SCEC – K&A Reviewed
Code B – Approved with Comments (Do not Resubmit)

PROJECT
JEDDAH OPERA HOUSE

TITLE:
OPERA BUILDING
VERTICAL TRANSPORTATION
PART 004
PLANS - LIFT SHAFT SHEET 01 OF 02 (L17)

DRAWING No: JOH-OTS-S5-01-056-004-ZZ-SD-VT-011020
REV: S00

1 Hoist Way Plan At "G" Floor (REAR) - ELEV-L17

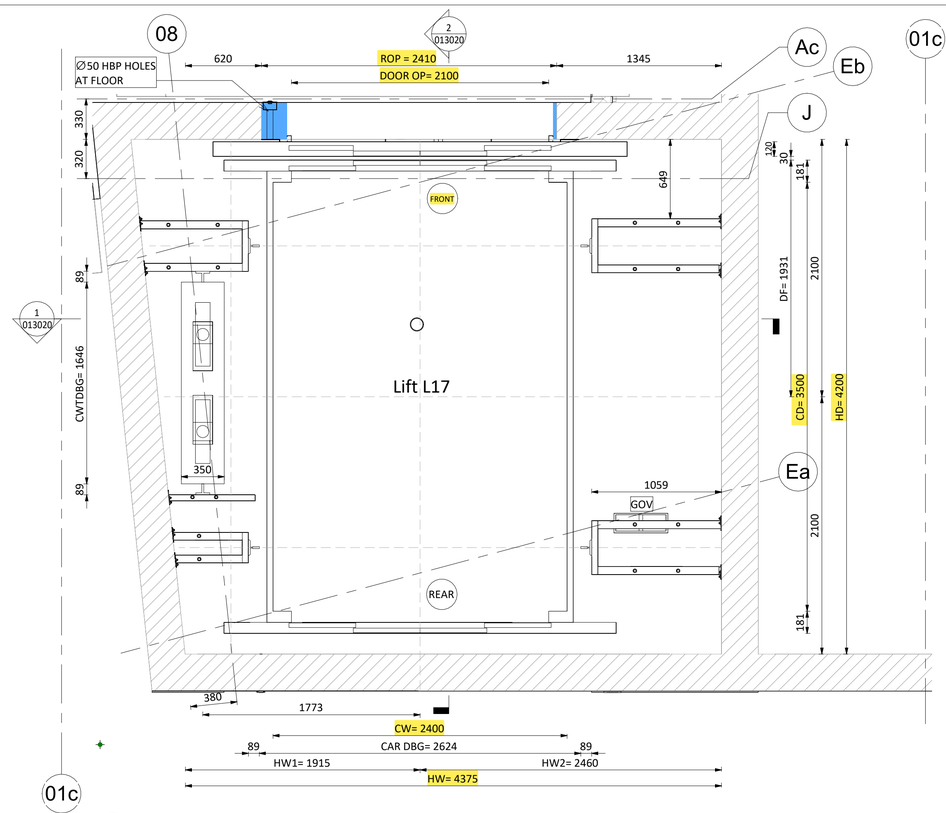
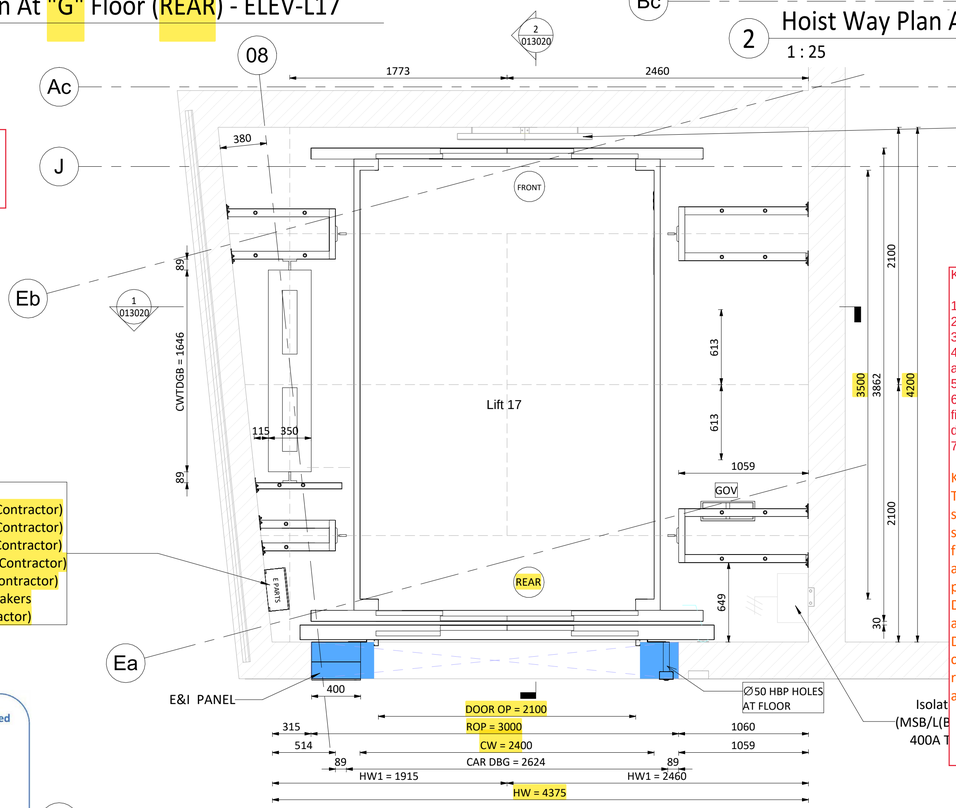
Contractor to submit a complete coordinated shop-drawing connection details with wall finishes ,architraves floor threshold connection for lift portal. Additionally, fire stop application detail to be submitted separately for review and FLS approval.

Shaft lighting to be provided and installed by ICAD

K&A ARCH COMMENTS :

1- Shaft size to be extracted from federated model.
2- Contractor must take in consideration as built dimensions and conditions prior execution.
3- FFL Levels shall match the federated model levels and as per site conditions.
4- Elevator Car Sizes/dimensions and Floors Being Served by the Elevators shall be as per approved TBE and further to OTIS letter TR-05809 and lift deviation letter.
5- Car interior finishes shall be submitted in a separate submission for approval.
6- Contractor to submit a complete coordinated shop-drawing connection details with wall finishes ,architraves floor threshold connection for lift portal. Additionally, fire stop application detail to be submitted separately for review and FLS approval.
7- Access ladder shall be submitted separately for approval.

K&A Acoustic Comments:
The 10 mm thick isolator bearings shall provide continuous separation between the steel bracket and the supporting structure, with no rigid metal-to-metal contact. The stabilizer bearings, elastomeric sleeves and washers shall be installed such that the fixing bolts do not create a noise/vibration bridge through the isolator. The fixing arrangement shall include suitable elastomeric sleeves/bushes and isolated washers to prevent direct transmission through bolts and fixings.
Disclaimer: K&A Khatib & Alami – Saudi Consolidated Engineering's review and/or approval does not relieve the Contractor of its obligations under the Contract Documents. The Contractor remains fully responsible for the accuracy, completeness, coordination, and compliance of all submitted documents and executed works. Such review and/or approval shall not constitute acceptance of, or entitlement to, any additional time or cost impact.

1 Machine Room Plan - ELEV-L17

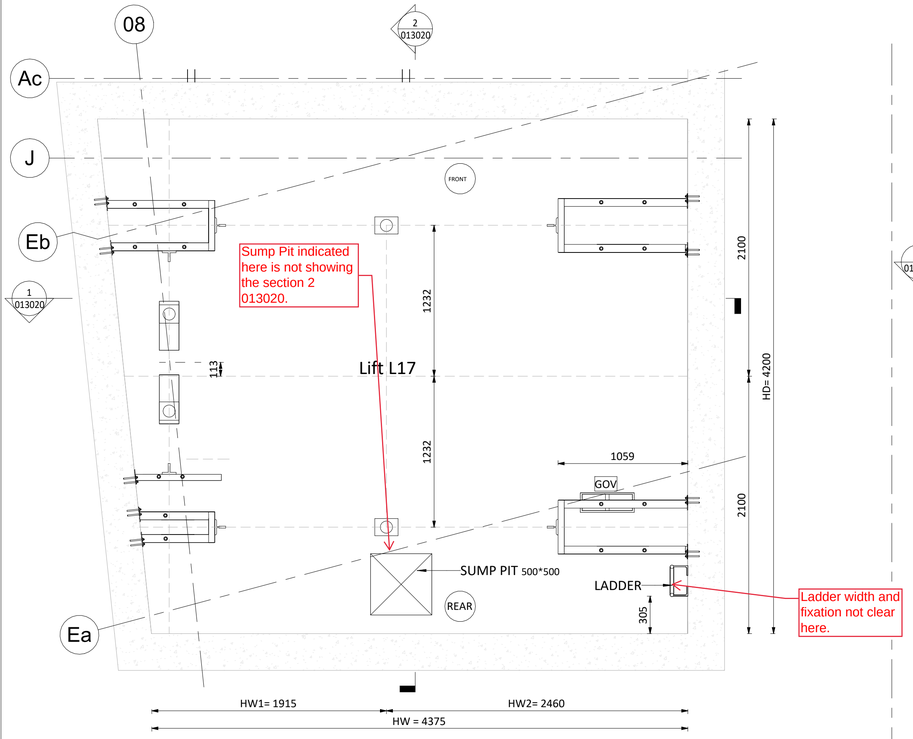
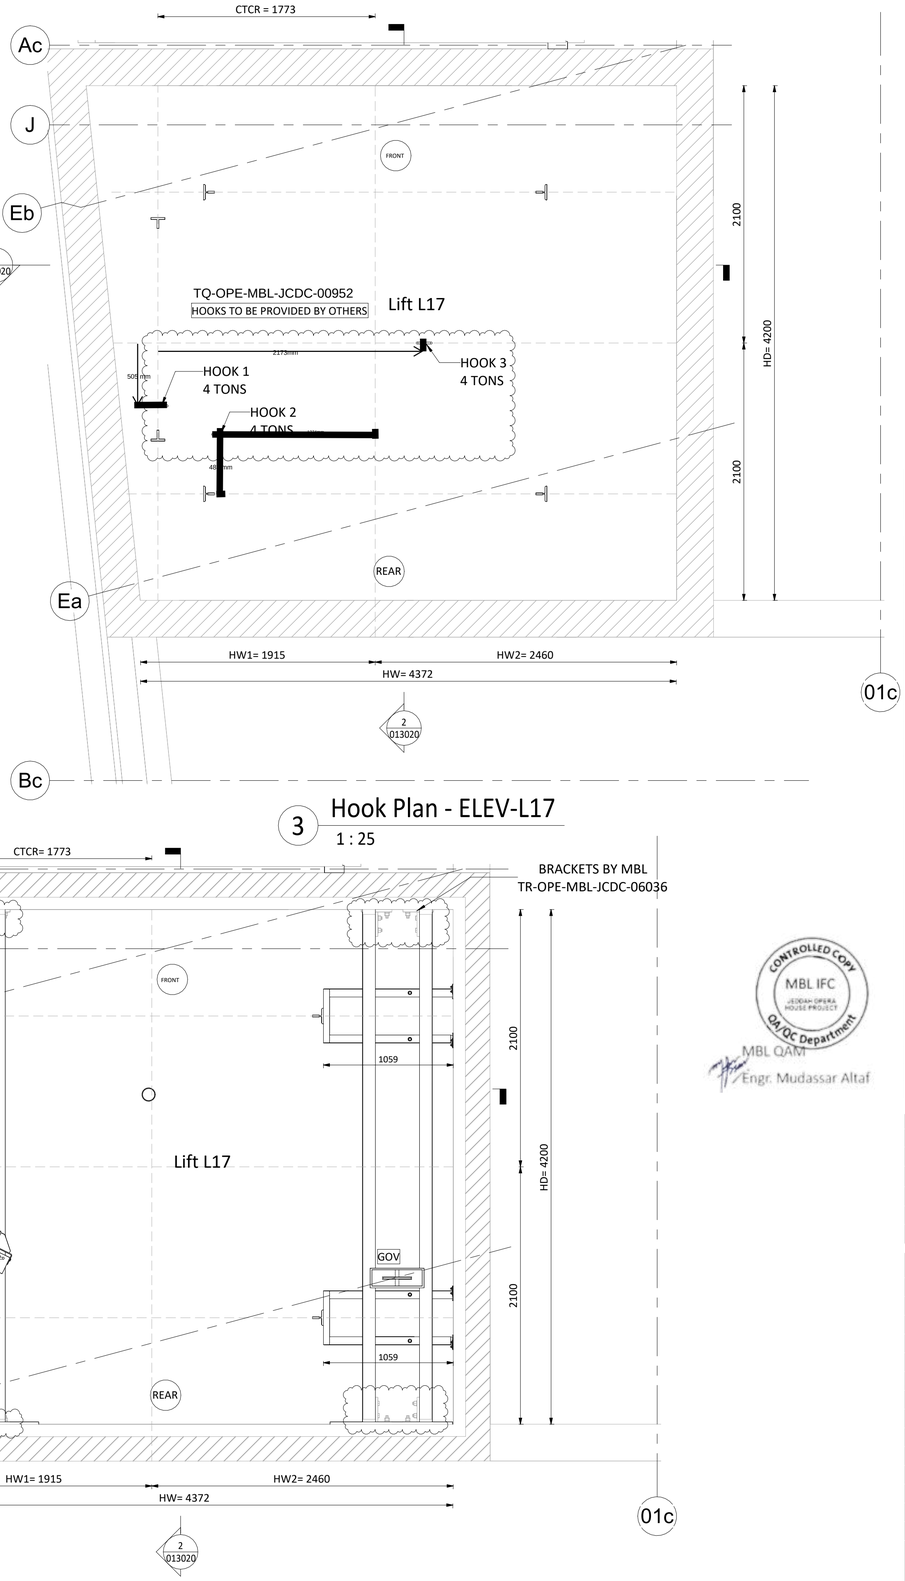
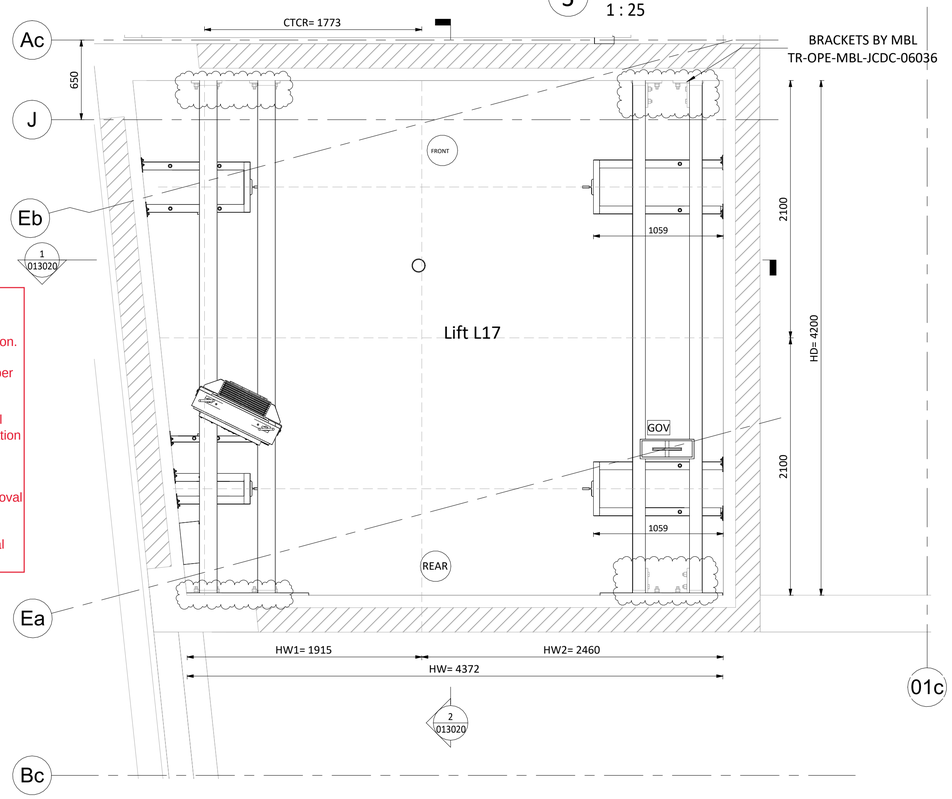
K&A ARCH COMMENTS :

1- Shaft size to be extracted from federated model.
2- Contractor must take in consideration as built dimensions and conditions prior execution.
3- FFL Levels shall match the federated model levels and as per site conditions.
4- Elevator Car Sizes/dimensions and Floors Being Served by the Elevators shall be as per approved TBE and further to OTIS letter TR-05809 and lift deviation letter.
5- Car interior finishes shall be submitted in a separate submission for approval.
6- Contractor to submit a complete coordinated shop-drawing connection details with wall finishes ,architraves floor threshold connection for lift portal. Additionally, fire stop application detail to be submitted separately for review and FLS approval.
7- Access ladder shall be submitted separately for approval.

1 Door Elevation At "G" Floor (REAR) - ELEV-L17
1 : 25

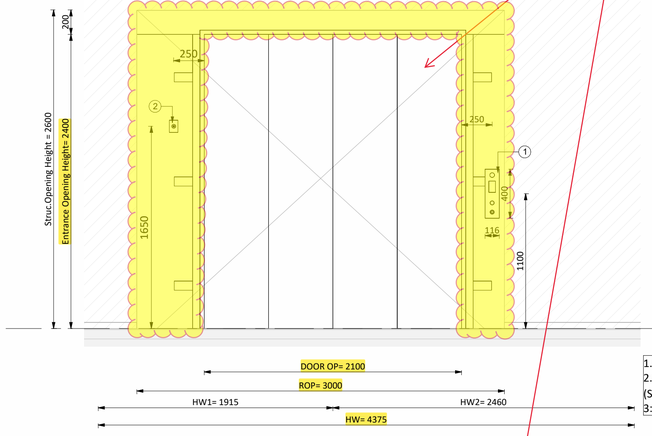
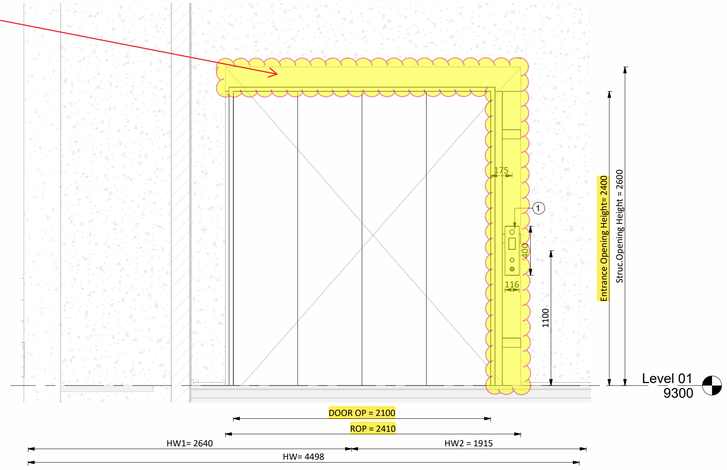
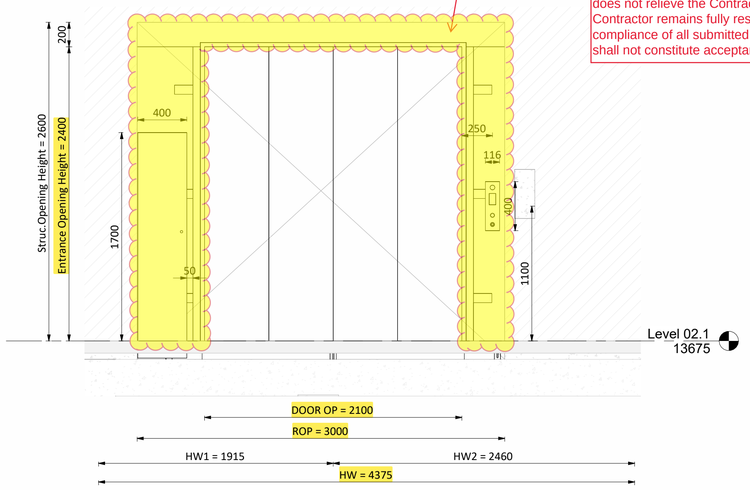
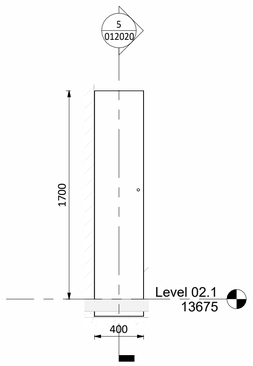
Wall built-up around the lift structural opening to be submitted for review and approval.

K&A ARCH COMMENTS :

1- Shaft size to be extracted from federated model.
2- Contractor must take in consideration as built dimensions and conditions prior execution.
3- FFL Levels shall match the federated model levels and as per site conditions.
4- Elevator Car Sizes/dimensions and Floors Being Served by the Elevators shall be as per approved TBE and further to OTIS letter TR-05809 and lift deviation letter.
5- Car interior finishes shall be submitted in a separate submission for approval.
6- Contractor to submit a complete coordinated shop-drawing connection details with wall finishes ,architraves floor threshold connection for lift portal. Additionally, fire stop application detail to be submitted separately for review and FLS approval.
7- Access ladder shall be submitted separately for approval.
